Early Site Permit (ESP) Application for the Clinton ESP Site
Docket No. 52-007

Subject: Final Safety Evaluation Report (FSER) Proposed Site Characteristic for
Probable Maximum Flood

Re: Nuclear Regulatory Commission (NRC) Final Safety Evaluation Report
(FSER) for the Exelon Early Site Permit (ESP) Application issued
February 17, 2006

Figure 3.2-1: Flood Flow Analysis at Rowell Gauge

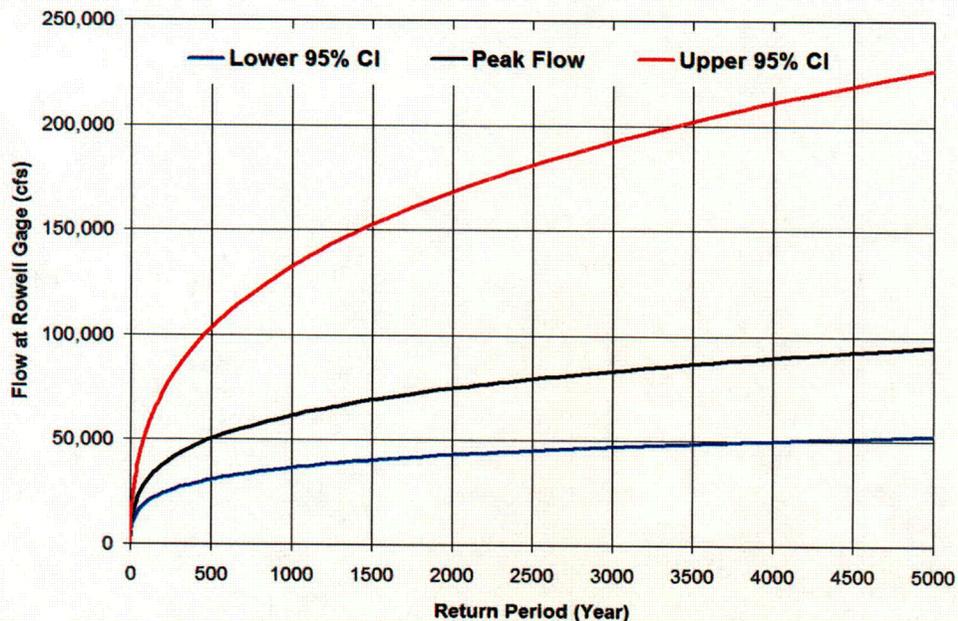
Comment: The NRC staff's calculation of runoff into Clinton Lake is unreasonably conservative. Table 2.4-6, for example, shows a maximum runoff event of 571,314 cfs. No observable data supports this calculation.

Based on this analysis, even the NRC calculated 1st-peak of 275,000 cfs does not seem to occur, indicating the occurrence of a second peak of 575,000 cfs is highly unlikely. In fact, expected flow flattens out. One can appropriately assume, then, that the flood flow predicted by the NRC is not probable. By application of probability principles, we see that the flow predicted by the NRC is significantly more conservative than required or necessary.

Figure 3.2-5: PMP Rainfall Distribution

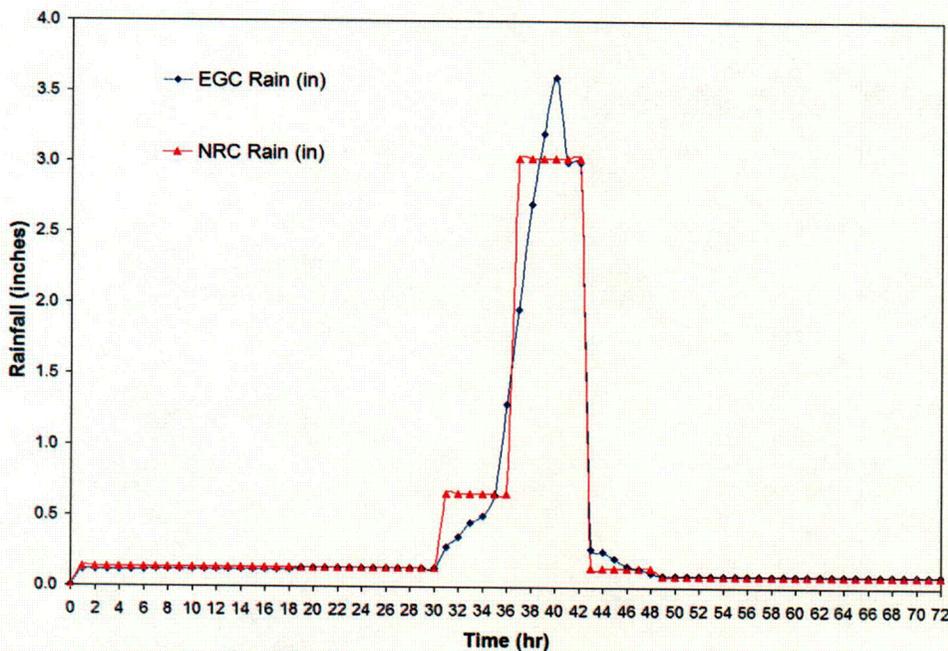
The resulting PMP rainfall distribution is shown in Figure 3.2-5. For this review, it has been compared with the rainfall distribution used by the NRC. It is worth mentioning that the 72-hr total rainfall used by NRC is 28.7 inches whereas EGC has calculated 27.8 inches. This difference may be due to the different values of the watershed area used by EGC and NRC. The watershed areas for Clinton Lake used were 289.2 and 296.0 mi² by NRC and EGC, respectively, as discussed in previous sections.

Figure 3.2-6: HEC-HMS Model Results Using Snyder's Method and Routing of PMF through Clinton Lake

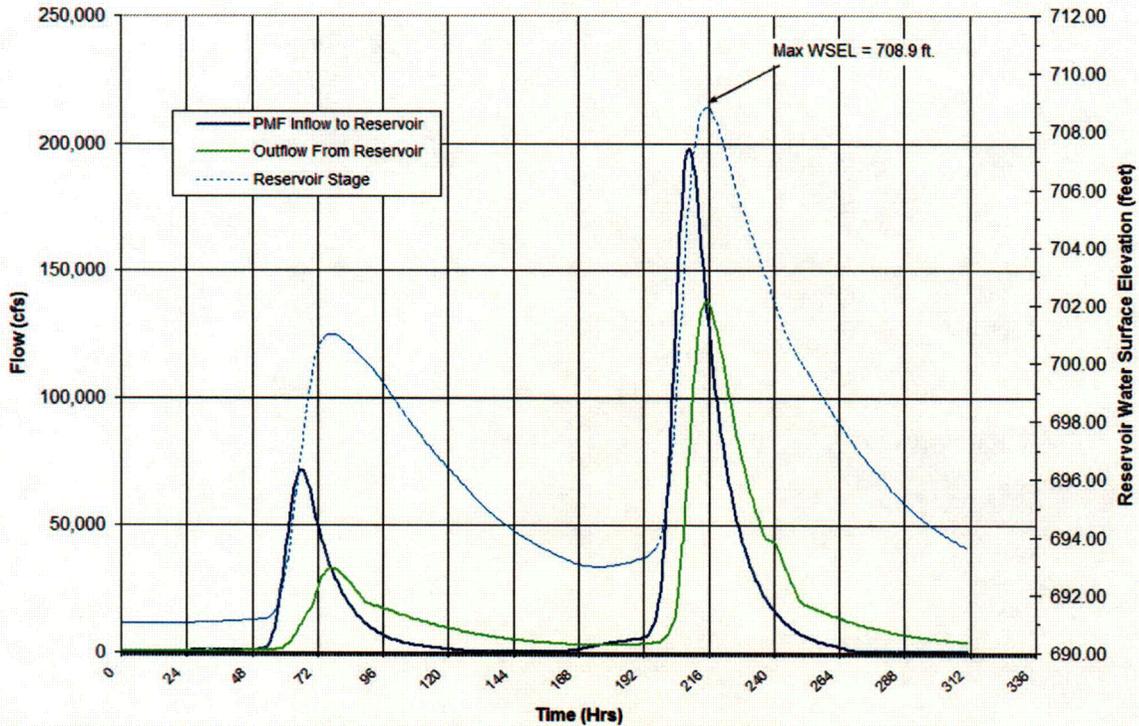
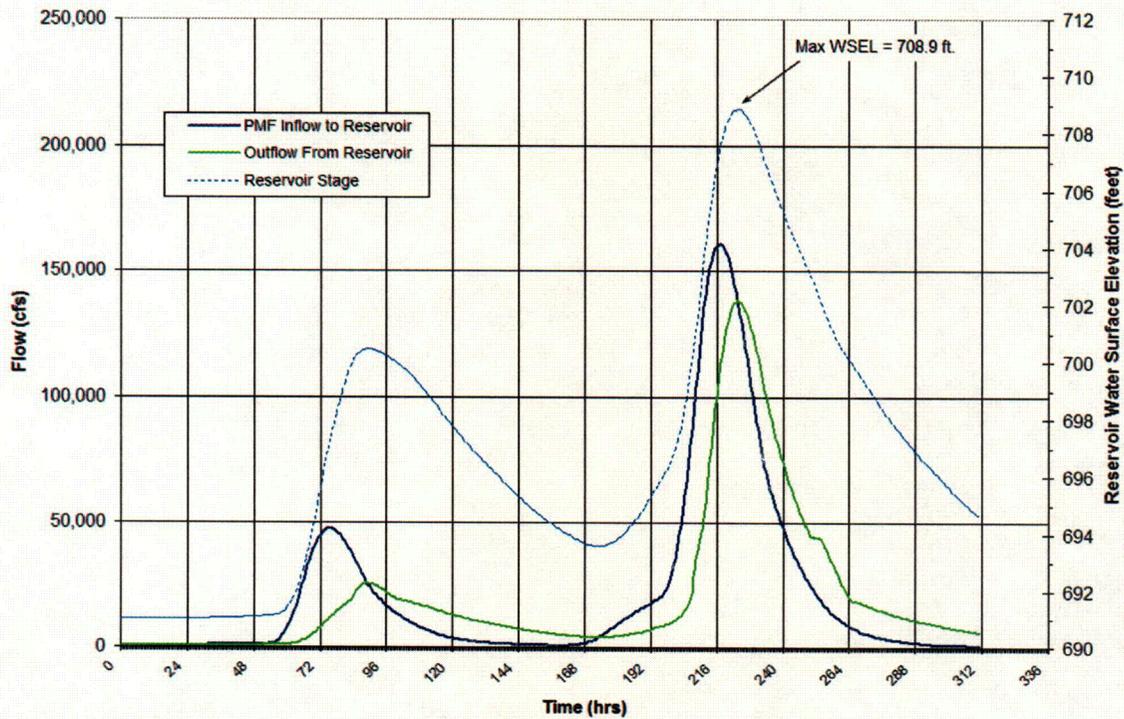
Comment: The FSER imposes a site characteristic PMF at 721.7 ft. MSL, based on the staff's "independent review." The site characteristic is based on a hydrostatic, or still water, flood elevation of 714.79 ft. MSL. This characteristic is too conservative, and imposes unreasonable conditions on the new plant and all existing infrastructures.

Discussion: The NRC staff review "independently assessed" PMF levels without regard to infiltration or response time. Even with the assumption of a smaller watershed, it is unreasonable to assume that a PMP event delivered to the watershed would be "instantaneous[ly] transfer[red]" to Clinton Lake. Rather, the calculations should include appropriate lag times, infiltration, and accurate responses of the watershed during a PMF event as identified in ANSI/ANS 2.8, section 5.2.8. The EGC team has performed a thorough review of the NRC staff calculations, and disagrees that the staff has reached an appropriately conservative design characteristic based on a PMF event.

Based on these methods, the hydrographs shown in Figures 3.2-6 and 3.2-7 were obtained. Both methods result in a maximum water level of 708.9 feet that agrees with the value submitted as part of the ESPA SSAR.

Figure 3.2-8(A): Comparison Of Unit Hydrographs For Various Sub-Basins Of Clinton Lake Watershed And Their Combined Unit Hydrograph For The Whole Watershed

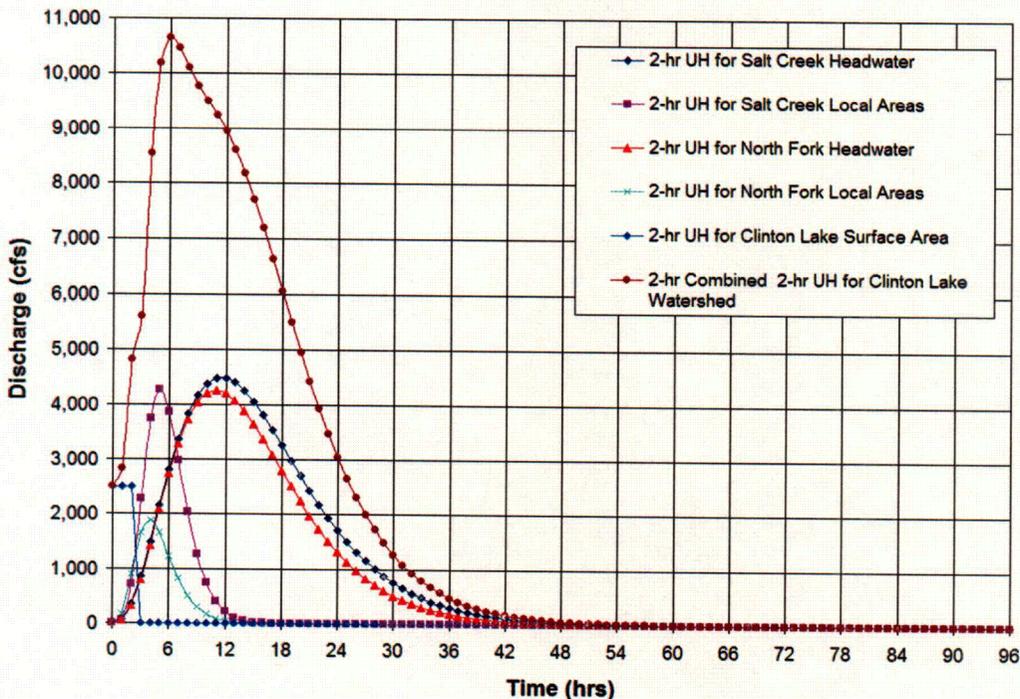
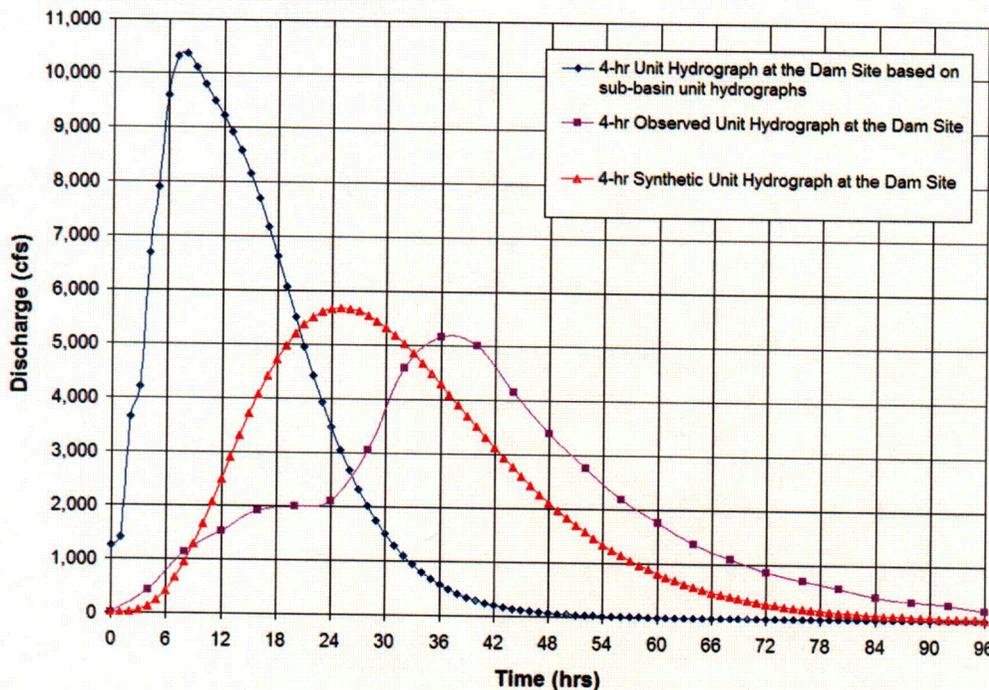
It can be further noticed that the lag times given in Table 3.2-4 have discrepancies. The overall lag time for the synthetic UH hydrograph is 24 h whereas the lag times of various component sub-basins of Clinton Lake watershed are less than 10.5 h indicating the inconsistencies between the overall lag time and lag times of various components of Clinton watershed. This issue is further illustrated in Figures 3.2-8 (a) and (b).

Figure 3.2-8(a) represents EGC ESP SSAR Figure 2.4-11, and additionally, combine them together to get an overall unit hydrograph for the Clinton Lake subwatershed based on its component sub-basins. Figure 3.2-8(b) compares this combined unit hydrograph based on various sub-basins of Clinton Watershed (after converting it into a 4-h unit hydrograph), with synthetic and observed hydrographs taken from the EGC ESP SSAR 2.4-10. The EGC team combined these materials to compare all of the figures relied on during the ESP application preparation. It is clear from Figure 3.2-8(b) that the combined hydrograph based on component sub-basins shows an overall lag time of 6 hours (T_P is 8 hrs). Whereas observed and synthetic hydrographs (both taken from 2.4-10 of the SSAR and replicated for this response) give an observed lag time of 36 hours and a synthetic lag time of 24h. The lag times based on a sub-basin components is not consistent with the observed or synthetic unit hydrograph. While reviewing Mitchell (1948) and SSAR Figure 2.4-1, the EGC team noted that the sub-basin component UH lag times (SSAR Figure 2.4-11) were obtained using the empirical relationship represented by Equation 5, and are not based on observed data as mentioned by the NCR team during the March 9, 2006 conference call. As a result, the lag time (12 h mentioned by NRC) based on the combined unit hydrograph is not reliable. While the observed hydrograph can be relied on, the synthetic curve is more conservative. It is suggested that use of the synthetic hydrograph representing the overall watershed hydrograph, which has a 24-hour lag time is more appropriate.

Figure 3.2-9: Comparison Between Observed And Synthetic Hydrograph At The Dam Site

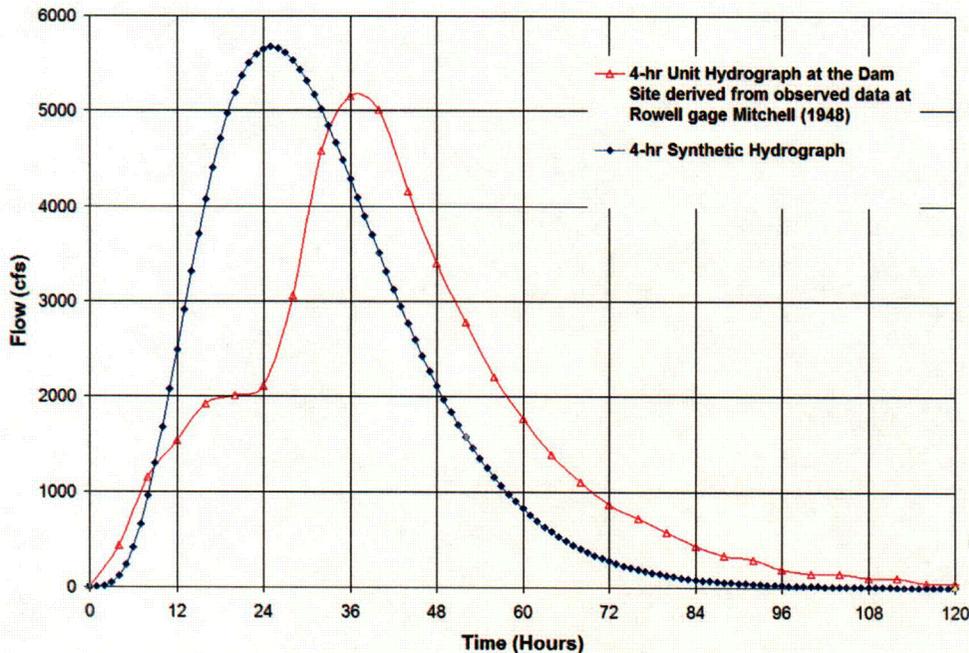
A previous analysis by EGC determined that an assumed lag time of 19.6 hours would produce a PMF elevation in Clinton Lake of approximately 708.9 feet. During a conference call on March 9, 2006, EGC asked NRC to consider a lag time of 19.6 as appropriately conservative. NRC requested support for the lag time of 19.6 hrs, compared with the lag time based on the observed data for Salt Creek at the USGS Gage near Rowell reported by Mitchell (1948). The NRC review team observed that a lag time based on Mitchell (1948) appeared to be 12 hours and asked for the rationale to support any other values.

The EGC team reviewed the Mitchell (1948) report but could not replicate or find 12 hours as the lag time for Clinton Lake watershed. Table 3.2-4 indicates that the lag time (using the EGC definition) for a 2-hr unit hydrograph is 24 hours. Based on this 2-hr unit hydrograph, a 4-hr unit hydrograph is developed and compared with the 4-hr unit hydrograph based on observed data (Figure 3.2-9).

It can be noted that the lag times for the observed and synthetic hydrographs are 36 and 24 hours, respectively.³
